## RESPONSE TO REQUEST FOR ADDITIONAL INFORMATION

### APR1400 Design Certification

RAI No.: 34-7870

SRP Section: 07.01 – Instrumentation and Controls – Introduction

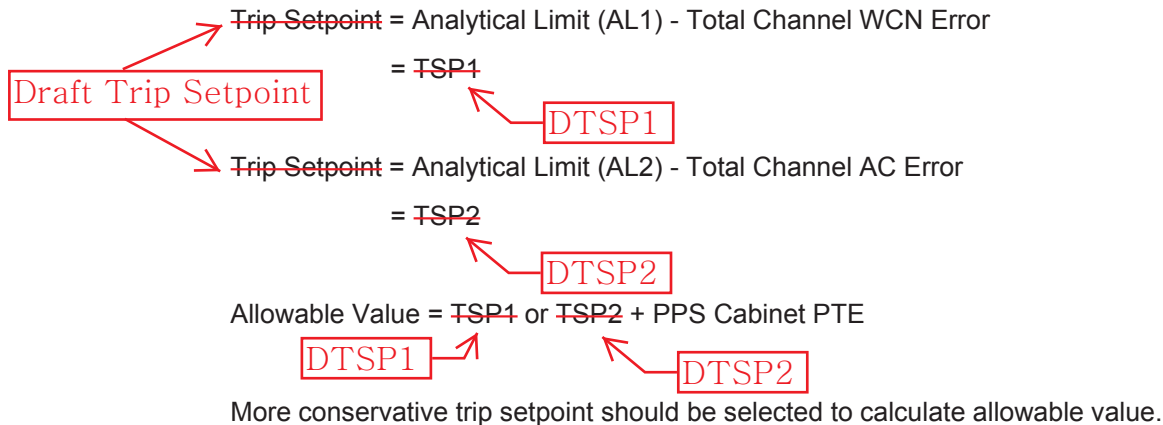
Provide consistent use of setpoint terminology.

The term of “Trip Setpoint” described in Section VI of Appendix A of the TeR means the “Draft Trip Setpoint” in Figure 1 of the technical report. To use consistent terminology between the technical report and its appendices “Draft” will be added to corresponding wordings in all Appendices of the TeR as shown in Attachment 1.
